# MORGAN OFFSHORE WIND PROJECT: GENERATION ASSETS

## Applicant's Response to Rule 17 Letter

Application Reference: EN010136

Document Number: MRCNS-J3303-RPS-10266

**Figure 4-2: Ben My Chree Transits during 2022 between Heysham and Douglas next to West of Duddon Sands.**

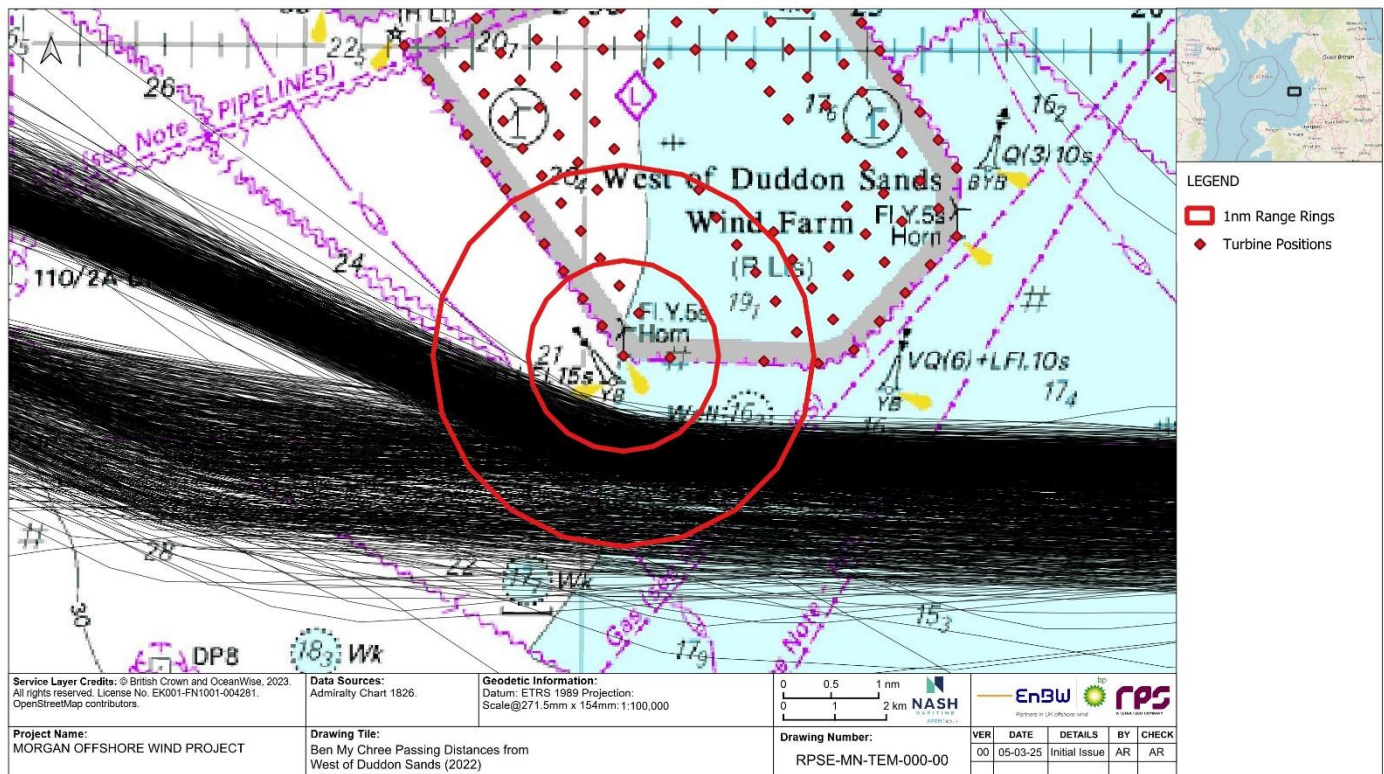
- The Applicant also notes that 2 nm passing distance from the offshore wind farms is inconsistent with typical operational behaviour. For example, more than 80% of all transits of the Ben My Chree during 2022 between Heysham and Douglas passed within 1.5 nm of the most south-westerly turbine of West of Duddon Sands, and 52% passing within 1 nm (Figure 4.2).

**Figure 5-1 Exact measurements from respective boundary set backs**

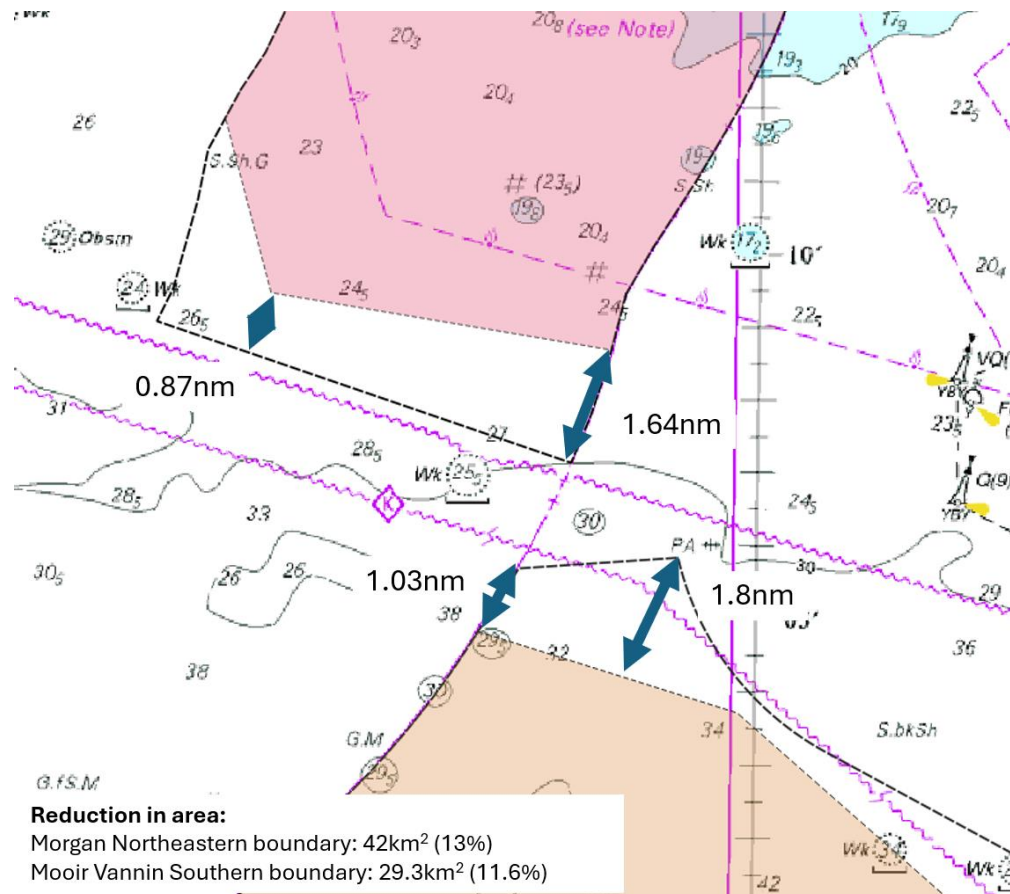
- 5.1.2.6 MVOWFL in its Deadline 5 submission (REP5-075) included comment on the design refinement for each of the Morgan Generation Assets and the Moir Vannin Offshore Wind Farm to support a submission that there had been a greater reduction in the developable area of the Moir Vannin Offshore Wind Farm. The information included in MVOWFL's submission does not present the full picture, which the Applicant considers it important to clarify as a point of fact, and has detailed this in Table 5.1 and Figure 5-1 below. The Applicant reduced a greater proportion of array area directly relevant to the gap between the Morgan Generation Assets and the Moir Vannin Offshore Wind Farm, than MVOWFL presented in their Deadline 5 submission (REP5-075). Further the Applicant has also collectively mitigated for a quarter of the total developable area (25-26%) and any further reduction would lead to considerable capacity loss. The current boundary concessions for both the Applicant and MVOWFL have proven to be ALARP and there should be no further requirement for any increased separation.
